CHATHAM COUNTY PURCHASING & CONTRACTING DEPARTMENT

ADDENDUM NO. 2 TO 18-0075-4

FOR: CANEBRAKE ROAD IMPROVEMENTS

Canebrake Road – Plan Revisions – 7/31/18

26-008

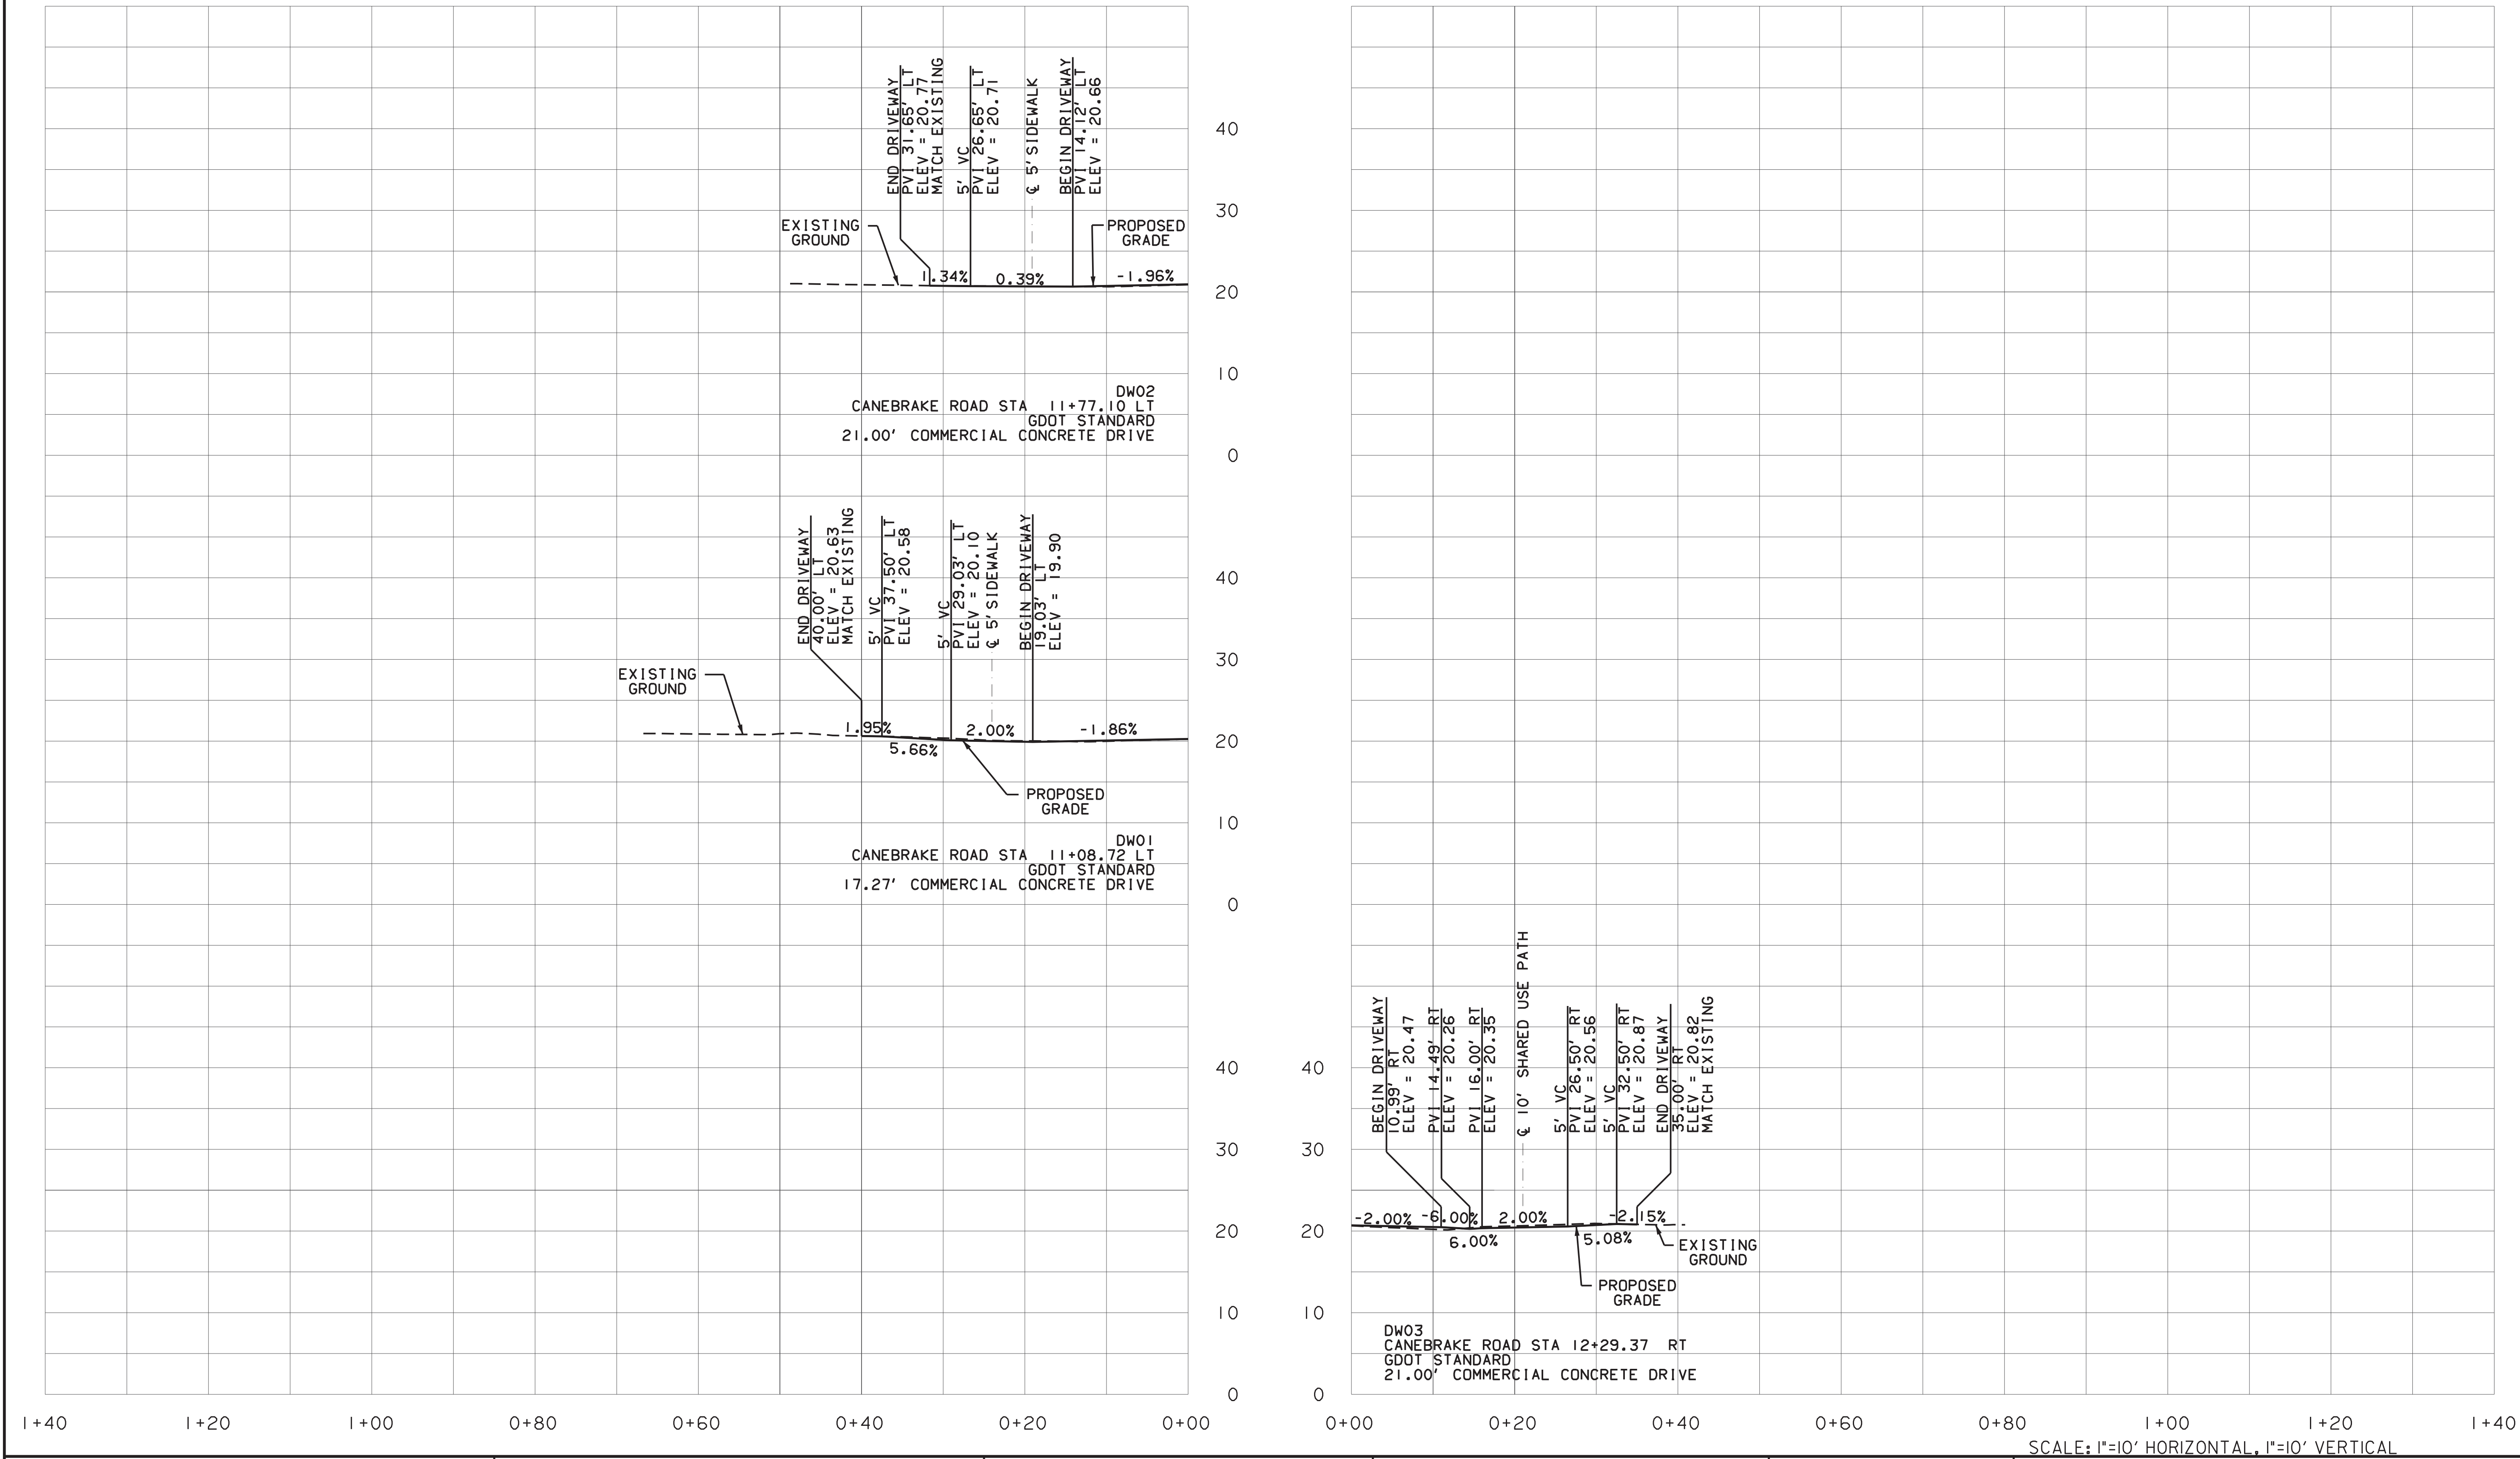
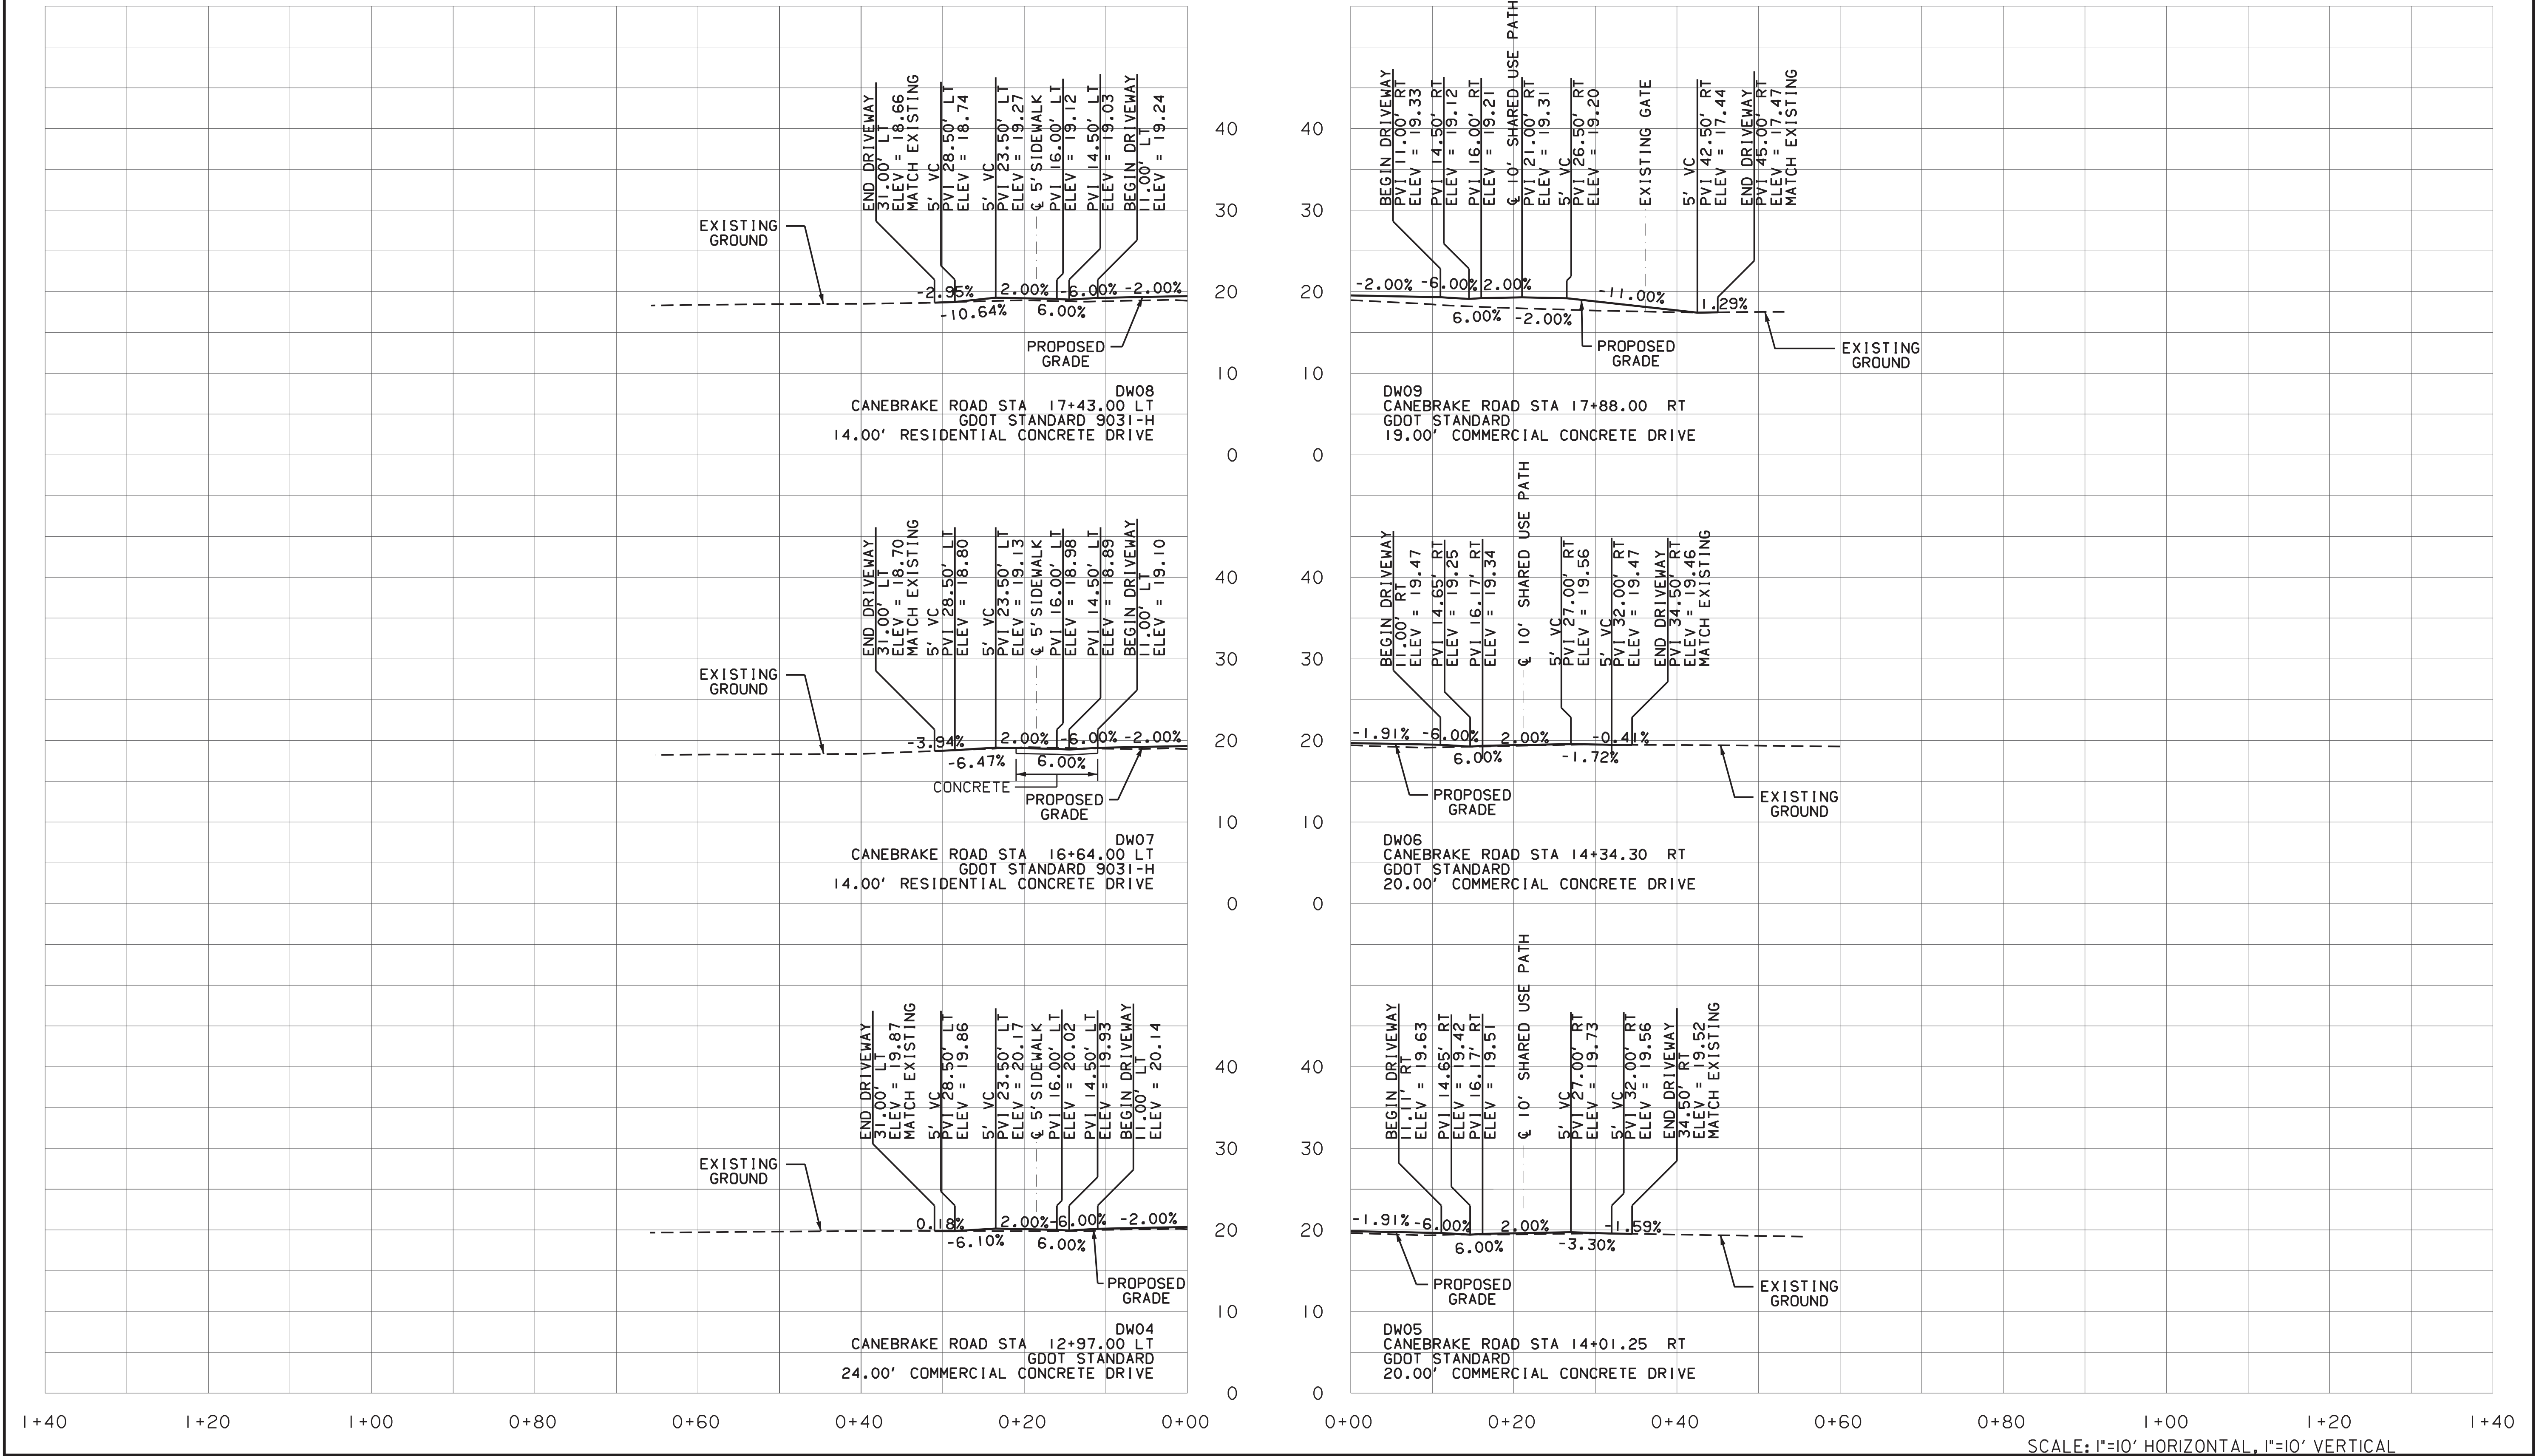
Sht 26-008: Added W11-15, W11-15P and W16-9P at 44+40 RT
